SUNSET DEVELOPMENT

PRELIMINARY OVERALL AREA DEVELOPMENT PLAN

Re: Sunset Development POADP # 629

SUBJECT: Sunset Development POADP; Level 2 TIA

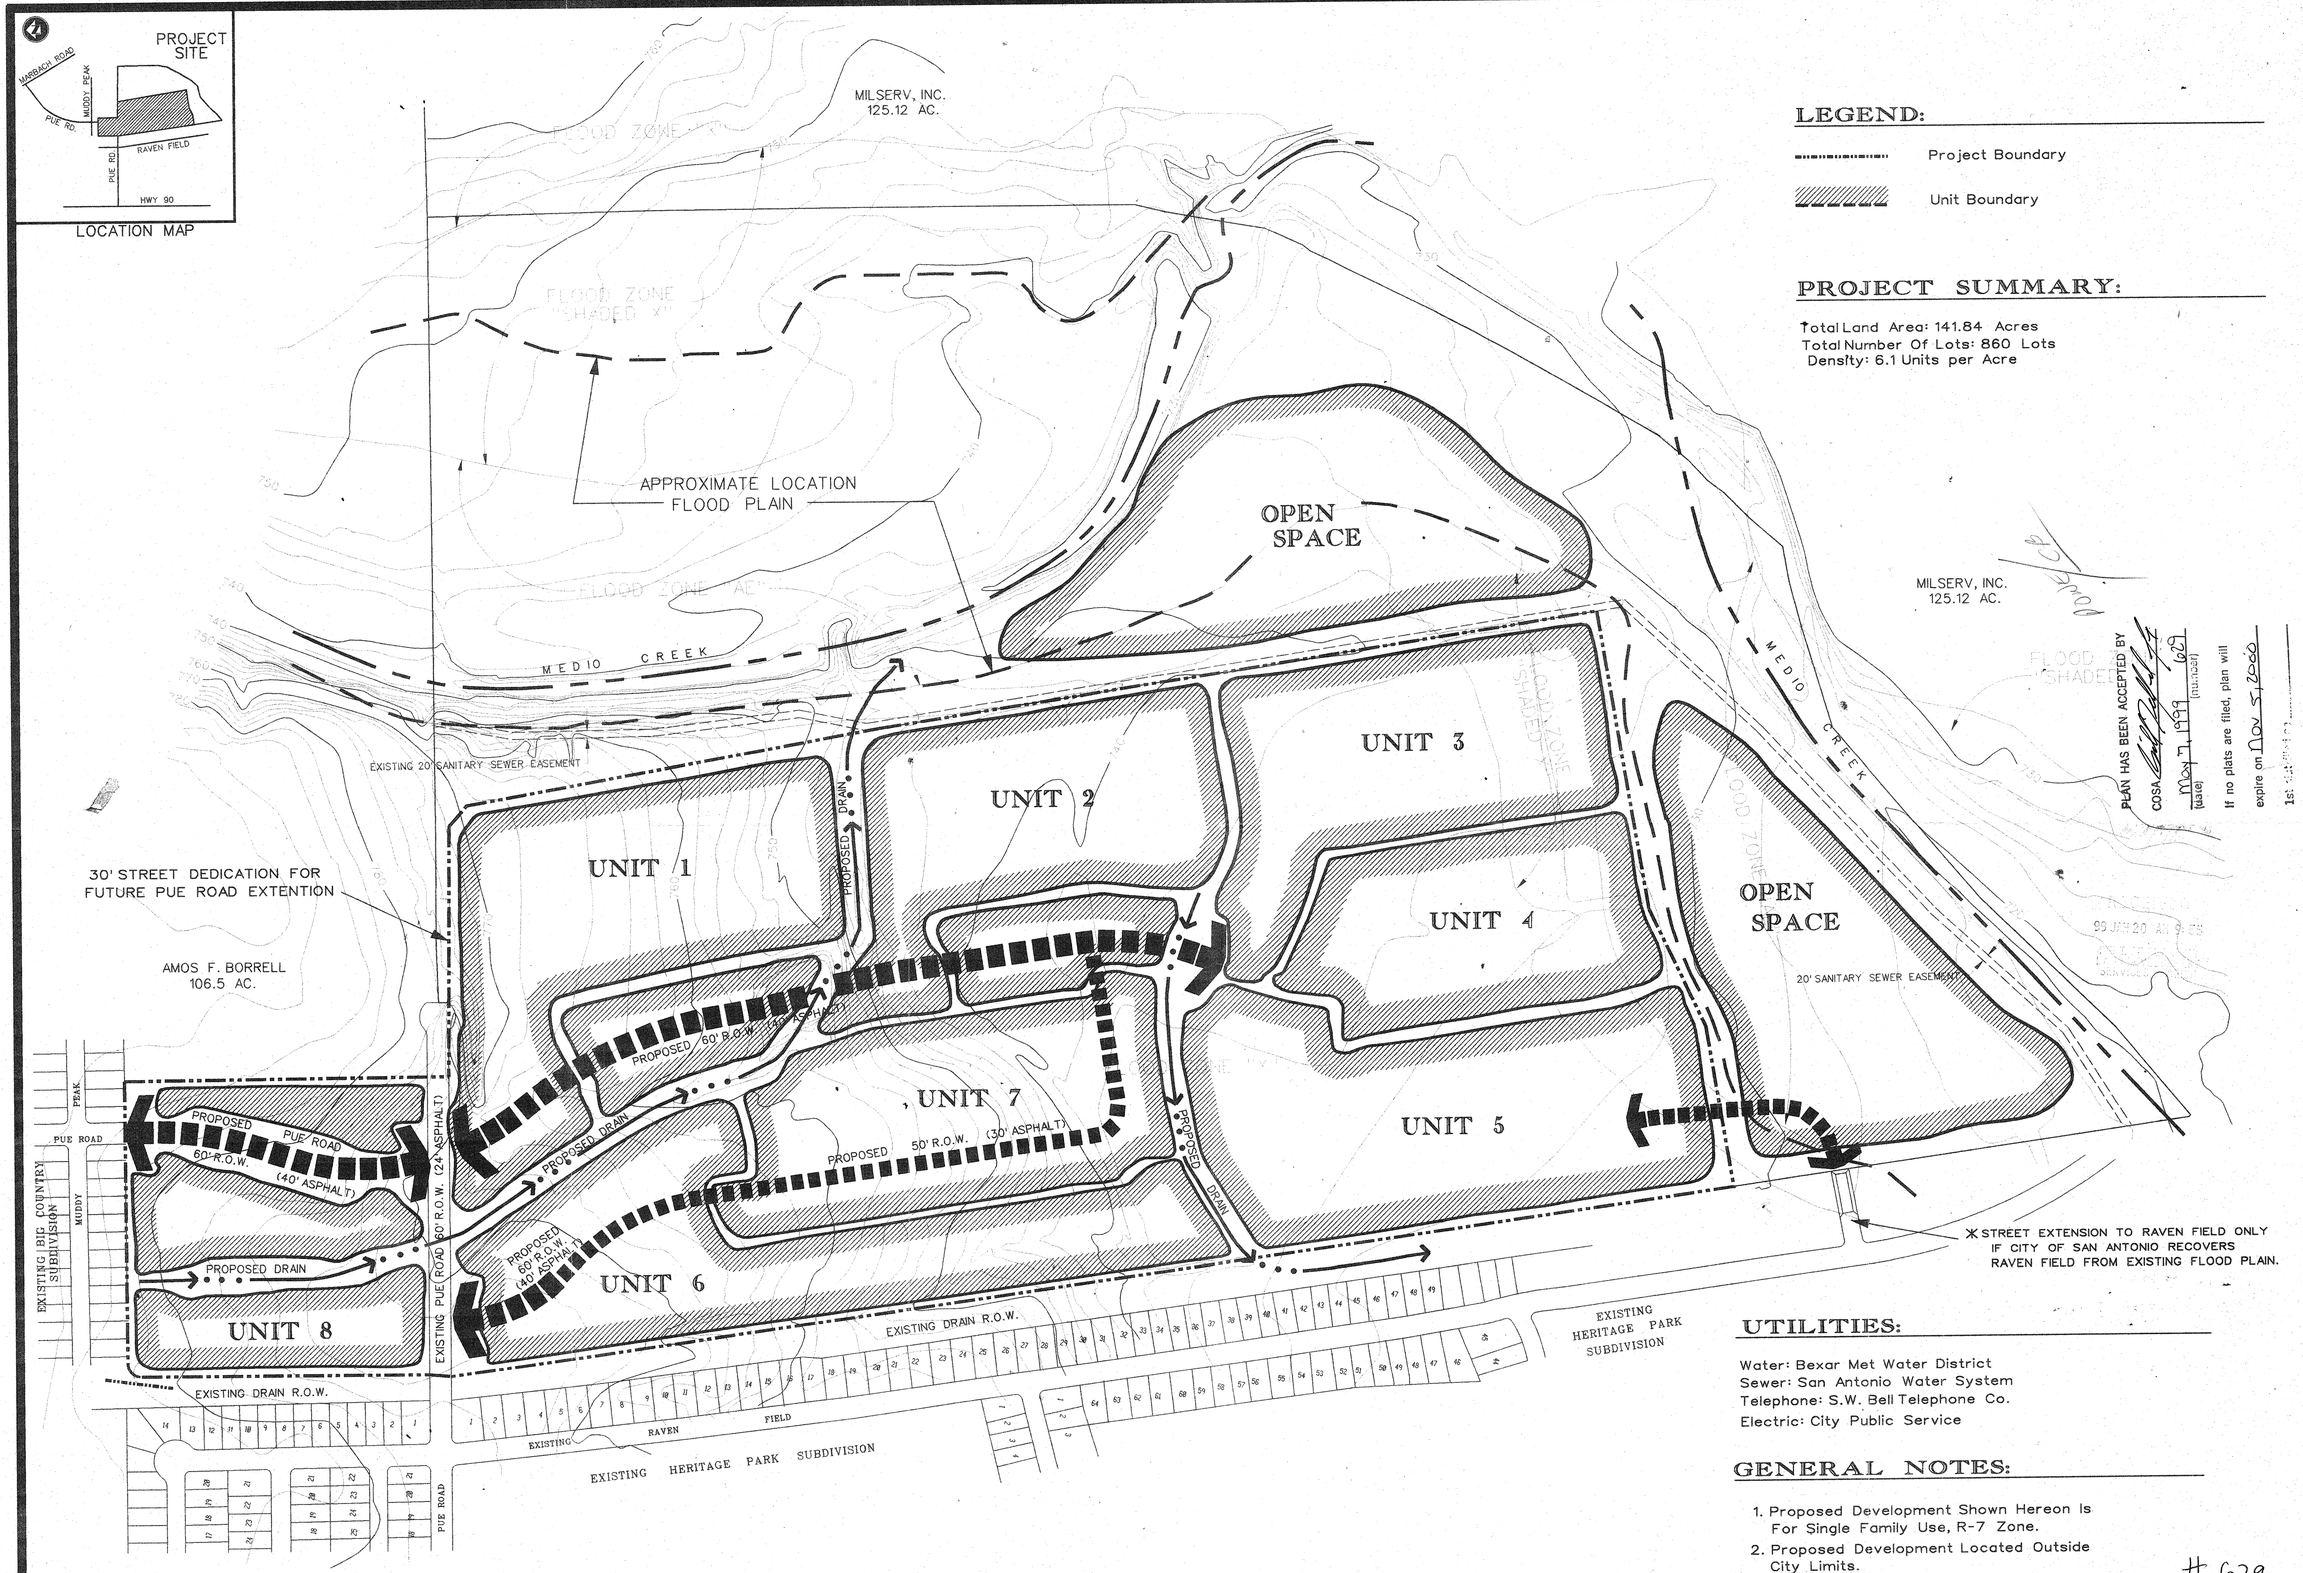
- Based on the topography, a Flood Plain Study and drainage review will probably be required during the platting process.
- Residential lots will not be permitted to front on Pue Road, in addition, The Pue Road ROW will need to be 60', in order to allow for the future expansion.
- In consideration of public safety and convenience, excessive grades by reason of topography should be avoided in street layouts and arrangements.
- This development will need to comply with tree preservation ordinance #85262. For information about these requirements you can contact Building Inspections at 207-7102.
- It will be expected that you will plat all of the property depicted in your POADP, to include: floodpains, drainage areas and open space.
- I would encourage you to work closely with the school district, so that they can plan accordingly.

The Streets and Traffic Engineering Division has reviewed the Level-2 Traffic Impact Analysis for the proposed Sunset Development located east of Pue and Marbach. By virtue of simply identifying the traffic impacts, it is in compliance with the Traffic Impact Analysis Ordinance 84917.

Located outside the city limits, this residential subdivision is estimated to generate 877 peak hour trips based on the 6th edition of the ITE Trip Generation Manual. According to W.F. Castella and Associates, these trips are expected to be distributed through only two access points, in combination with existing traffic generated from the Big Country and Heritage Park Subdivisions. The first access point is located on Pue & Marbach, near the Big Country Elementary School, and the second is located on Pue & U.S. Hwy 90.

Although the A*verage Daily Traffic (ADT)* will increase 112 percent, from 7,379 ADT to 15,609 ADT, no provisions for additional access has been indicated by the developer. A solution to this *significant traffic congestion* requires direct access north across Medio Creek to Marbach Rd.

o Sunset Development consider rejection traffic overloads too many existing streets no alt. shown to handle traffic. Connect bootleg over Medio
No conductivity for traffic

- better roads
- north + south movement
- units per phase
- access to open space (pedestrian)
- future access pt. for cirulation
- bigger map
- cross medio creek (bridge)
- bigger picture

* remove drainage note from POADP.
- TIA
- drainage

- Pue needs to remain 60' thru the propert.
- no residential lots fronting on Pue.
